**LEE COUNTY HISTORIC PRESERVATION BOARD
OLD LEE COUNTY COURTHOUSE
2120 MAIN STREET
FORT MYERS, FL 33901
EAST ROOM**

AGENDA

A. COA 2011-00167 Wilson Residence, 16281 Quail Trail, Bokeelia, FL 33922

B. COA2011-00111, Goldpenny, 4725 Pine Island Rd, NW, Matlacha, FL 33993

REVISIONS

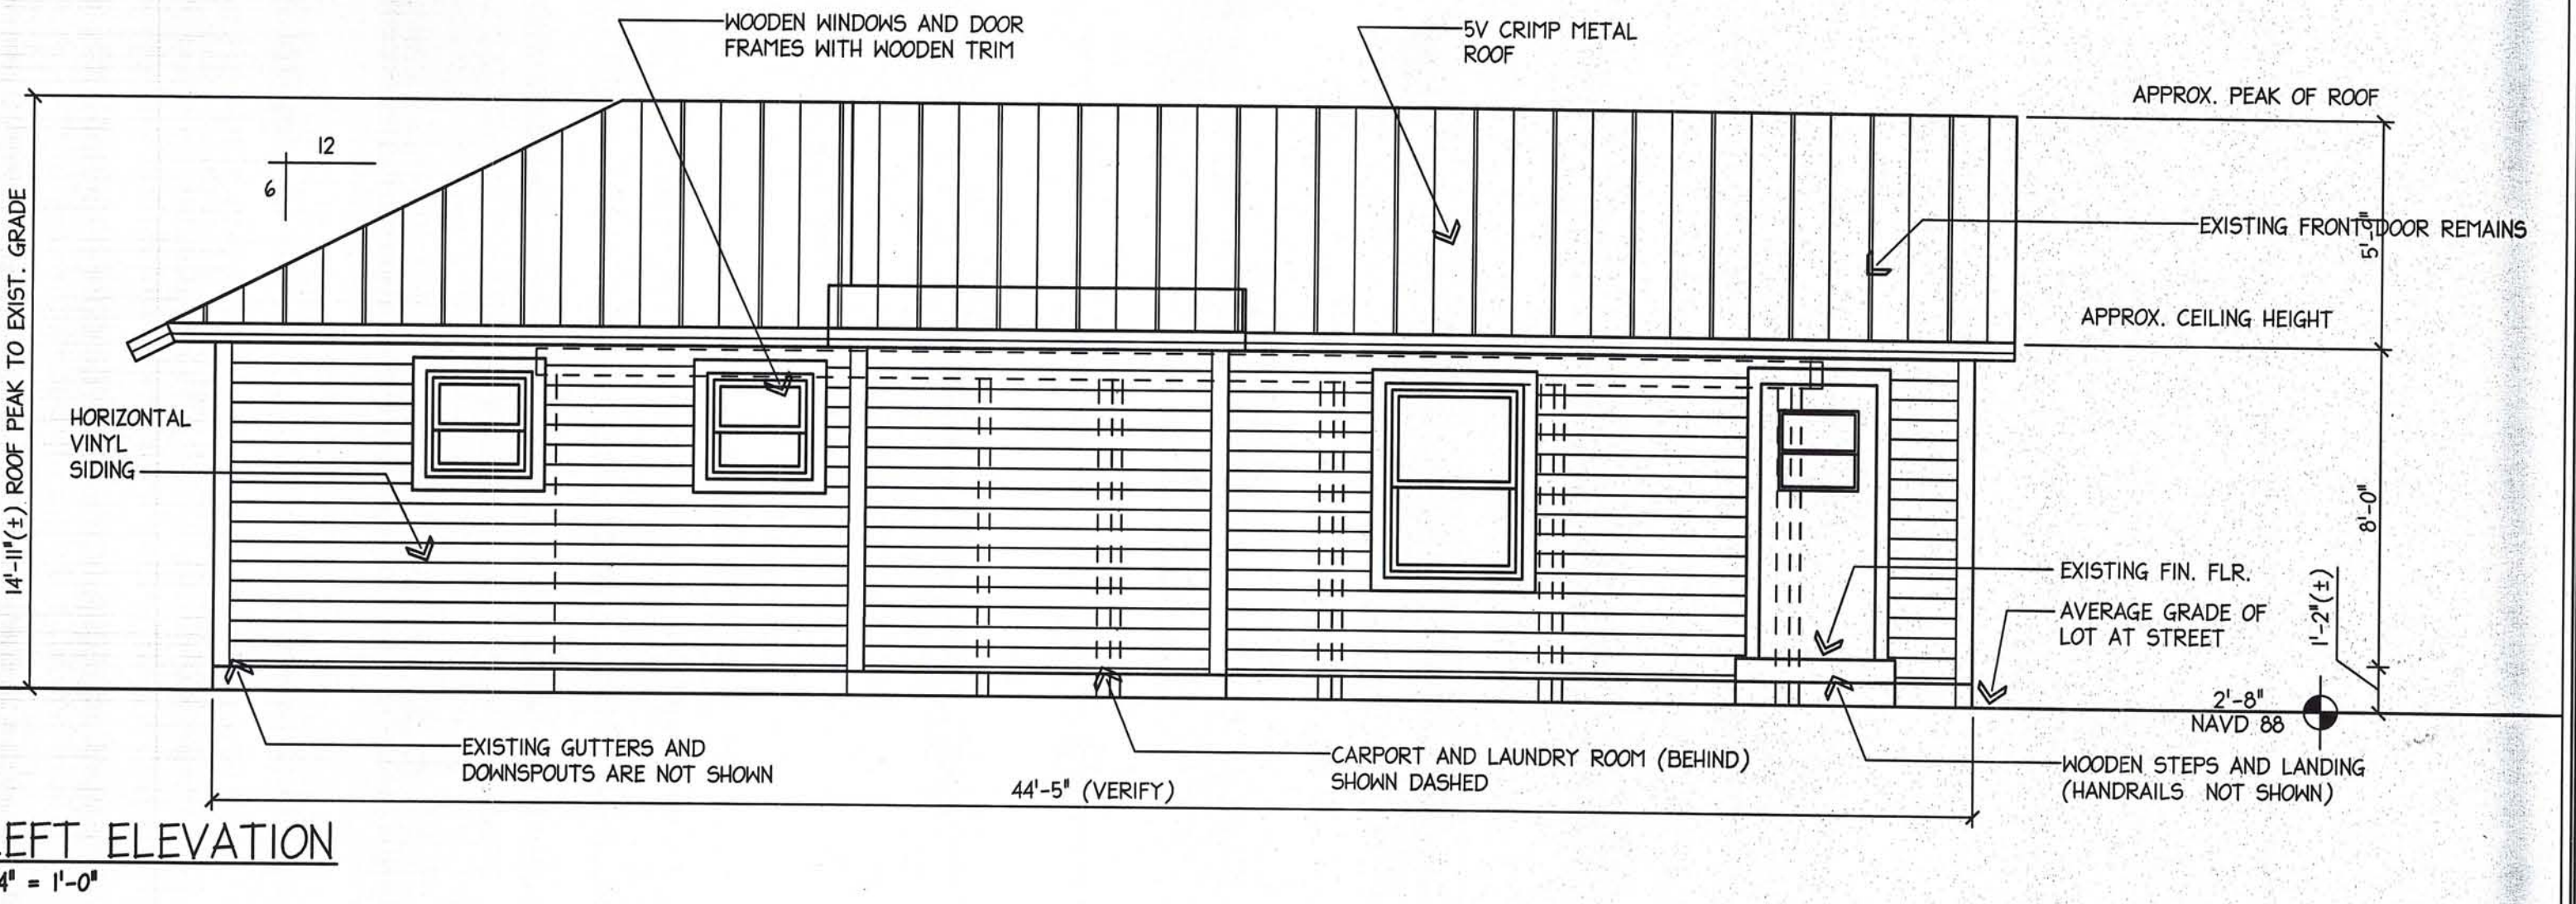
1. Relocation of the house on the site to increase the front setback area. Currently the house has a roughly 2-ft setback from the front property line along Pine Island Rd. The proposal would relocate the entire house as is and increase the setback from the front property line to 10-ft. The new increased setback would be in line with the setback of the adjoining property to the north. A larger front setback area would provide a greater, safer buffer between the house and Pine Island Rd. Safety is a consideration particularly given that the house will have to be handicap accessible. Staff supports this change.

2. Elevating the house from roughly 1-ft 2-in above grade to 4-ft 4-in above grade in order to meet flood elevation. The request is to raise the house by 3-ft 2-in above the current elevation. This would provide greater protection in case of flooding and make the house compliant with flood regulations – which would make it easier and less costly to obtain insurance. Most of the houses along Pine Island Rd in the Matlacha are at or a few feet above grade. Raising the house 3-ft 2-in is a relatively small increase. Overall the height of the house would still be in keeping with the height of other houses in the district and the house would have added protection from flood waters. The proposed change would increase the height of the house from roughly 14-ft 11-in from grade to roof peak to roughly 18-ft 1-in (or increase it from roughly 13-ft 9-in from finished floor to roof peak to roughly 16-ft 11-in)

The elevated house would feature new brick foundation piers with lattice infill between the piers. This type of foundation design is typical of the vernacular houses found in Lee County and in Matlacha. Due to the installation of the handicap ramp (see below) the door towards the rear on the south side will be removed and replaced with a window. Staff supports this change.

While the applicant has tried to minimize the impact of the second floor addition, staff objects to the addition because it will substantially alter the massing, size and scale of the building. The house is a small single story building which at some point in time had slight additions to the rear and north side elevations. Adding a second story would radically change the original design of the building.

There is no compelling reason to add a second story to the building. The house sits on one of the larger lots in the Matlacha Historic District and the house could easily be enlarged by 401 sq ft by placing an addition at the first floor level.

The second floor addition at the rear is not recommended for approval as it involves not a minimal change but a drastic change to the single story design of the house, which is a defining characteristic of the building. Also the addition of a second story would be a substantial change to the environment of the building. The environment of this building is the Matlacha Historic District along Pine Island Road and in the vicinity of the subject property. (See attached photographs) This area of the district predominantly composed of small, single story buildings. This proposal does not meet this standard.
